Staff Analysis of a Proposed Amendment to the *Dane County Water Quality Plan* Revising the Sewer Service Area Boundary in the Verona Urban Service Area

Figure 1: Proposed Well Construction

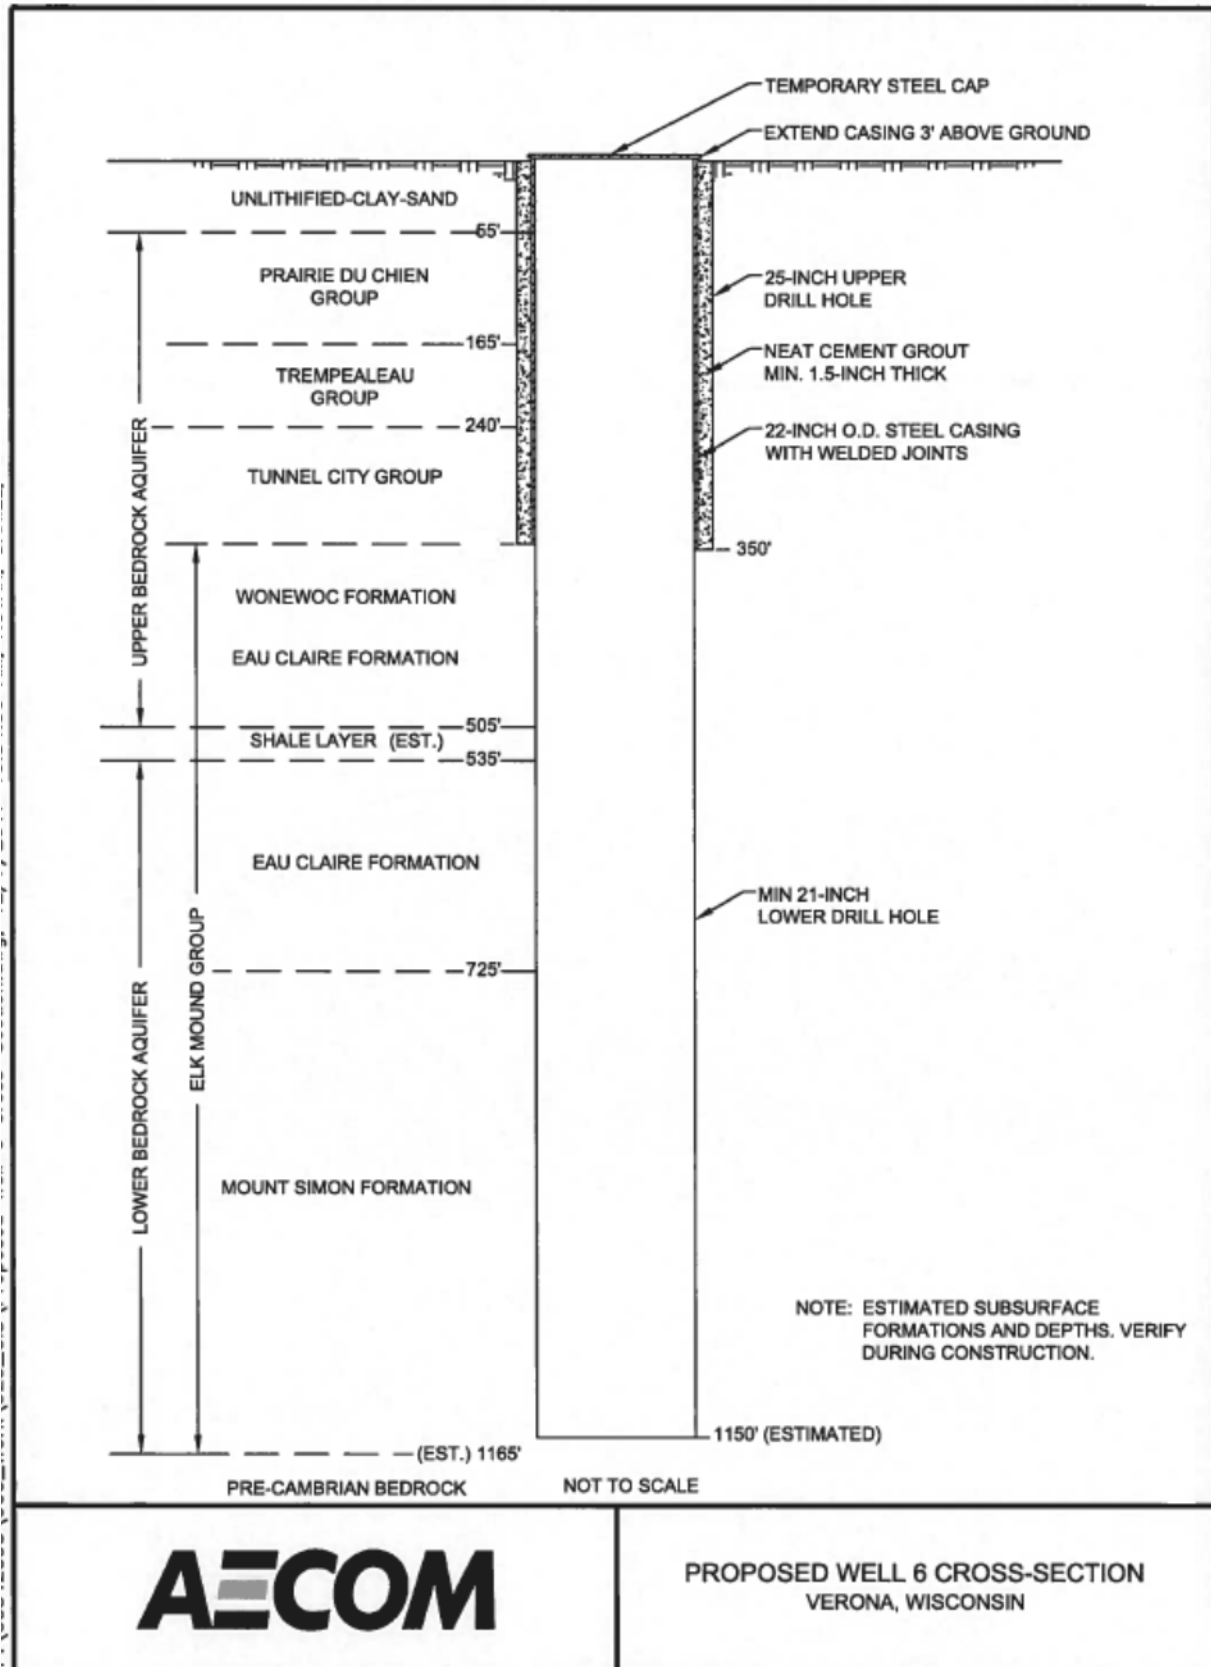
High-capacity wells with shallow casings create a vertical conduit that can allow groundwater contaminants to move rapidly between the shallow and deep bedrock aquifers. This is particularly a concern in areas known to have significant nitrate contamination in the upper aquifer, as is the case here. The [*Groundwater Protection Planning Framework of the Dane County Water Quality Plan*](#), recommends that high-capacity wells should be designed (e.g., adequate casing depth, etc.) to be sure to avoid cross-connecting the shallow and deep aquifers across the Eau Claire aquitard. It is recommended that the City of Verona construct their municipal well to be cased and grouted through the Eau Claire Formation to reduce the potential for high nitrate levels in the water supply well as well as reduce the possibility of cross contamination by not cross connecting the shallow and deep aquifers across the Eau Claire aquitard.

1. The municipal well should be cased and grouted through the Eau Claire Formation to reduce the potential for high nitrate levels in the water supply well as well as reduce the possibility of cross contamination by not cross connecting the shallow and deep aquifers across the Eau Claire aquitard, as recommended in the [Groundwater Protection Planning Framework of the Dane County Water Quality Plan](#).
